3040 R St., NW / 2ND FLOOR UNIT WINDOW REPLACEMENT

REPLACEMENT OF WINDOW SASHES AT EXISTING 2ND FLOOR CONDOMINIUM UNIT. NOTE 3RD FLOOR UNIT WAS PREVIOUSLY REVIEWED / APPROVED FOR SIMILAR WORK.

ISSUE
10/05/20 HPO / CFA Rev.

COVER SHEET

2ND FLOOR / FRONT ELEVATION

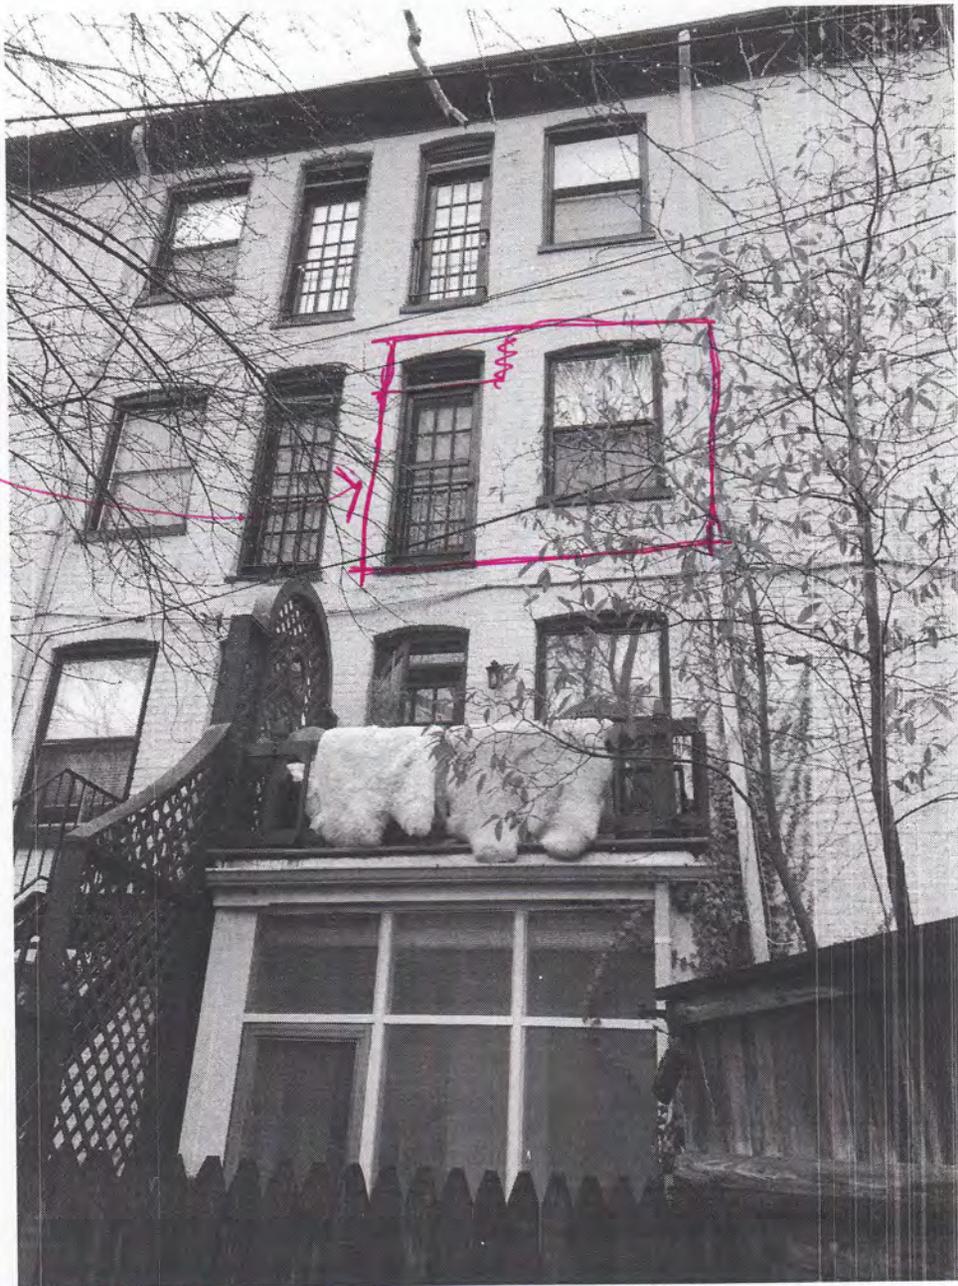
Beth -
* Note that the 2nd floor existing window
is $\frac{3}{2}$ lite windows. Mike ordered $\frac{1}{1}$ lite.
hoping we can argue that every other window
on this building and next door are also all $\frac{1}{1}$ lite.

Pella® Reserve™ Traditional Hung Window

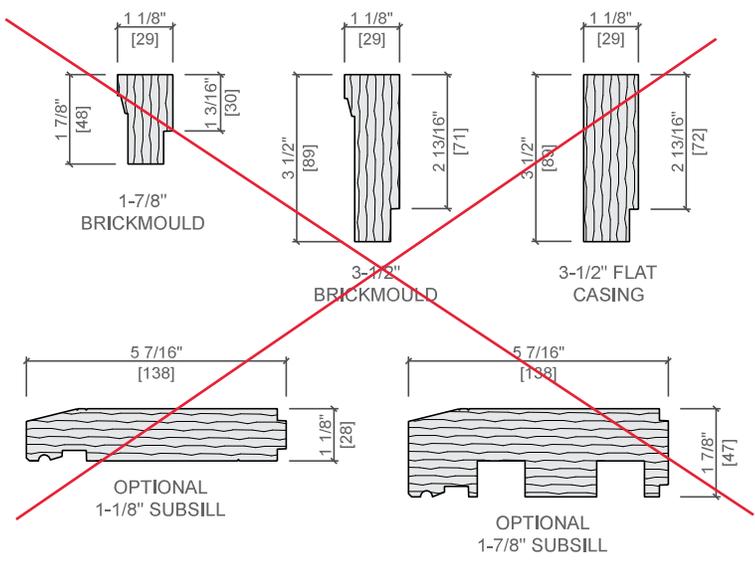
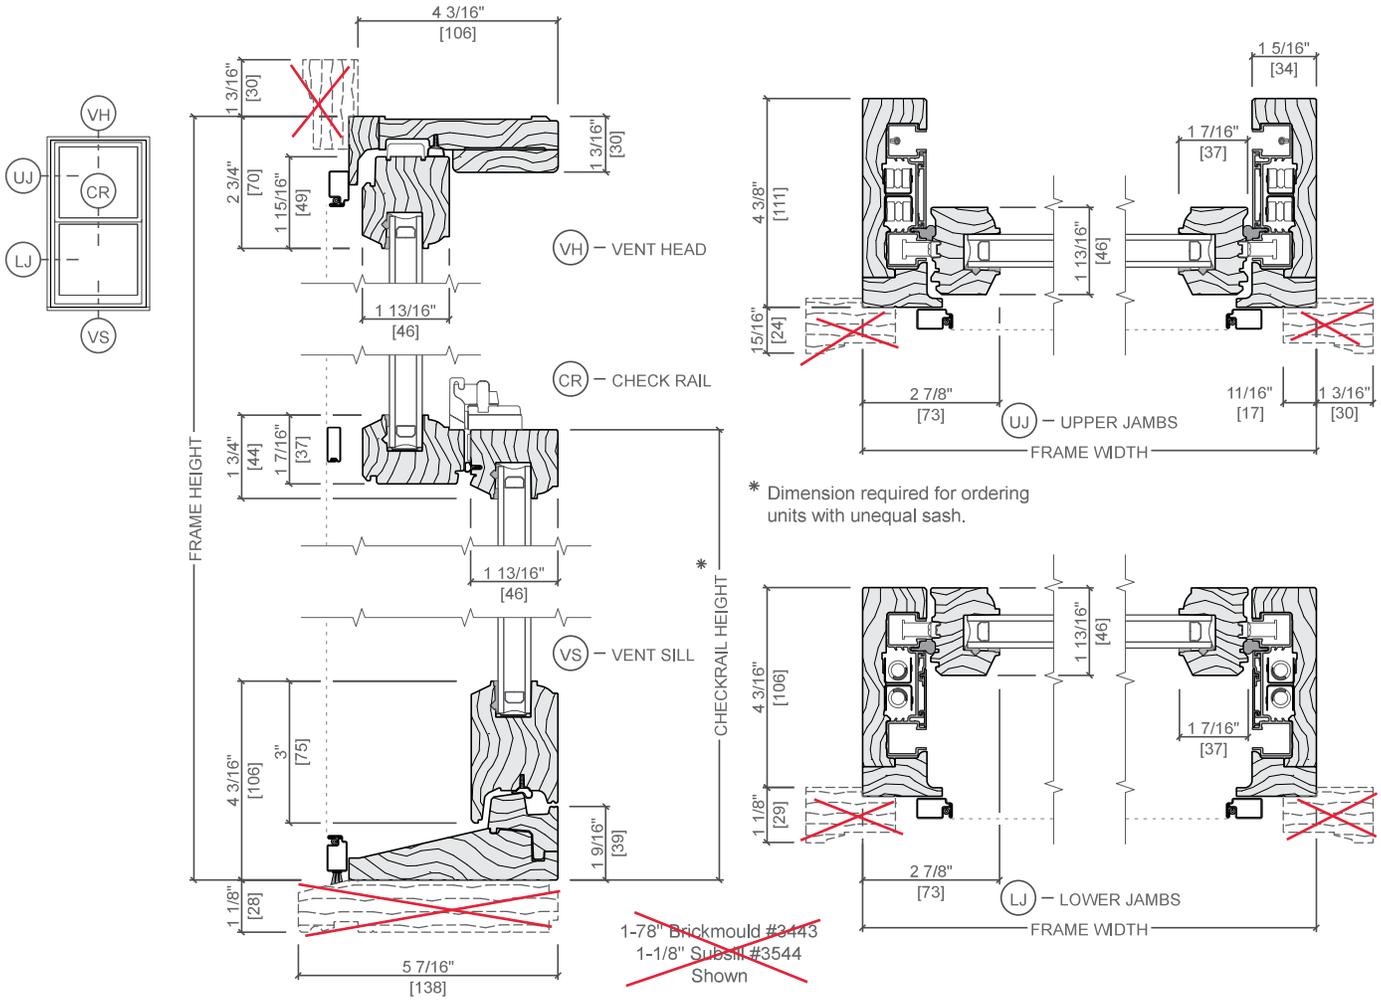
- Please revise the window specs for either half screens or no screens. If storm windows are desired, they should be interior storms, and no vinyl jamb liners, per the OGB Window Design Guidelines.

- These windows appear to be double-glazed; the OGB requires single-glazed on all street-facing elevations. They do consider double-glazed units on the rear, however, they review such replacements on a case by case basis. You may want to consider single-glazed windows for the front elevation, at a minimum.

SCH - There will be no storm units. Per Pella specifications, the jamb liners are not vinyl.

SCH - Owner requests consideration for insulated glazed window units for energy efficiency per current DCRA energy code requirements. Windows specified for this review are a simulated divided lite unit with spacer bar. This was same as previously reviewed / approved for the 3rd floor unit.
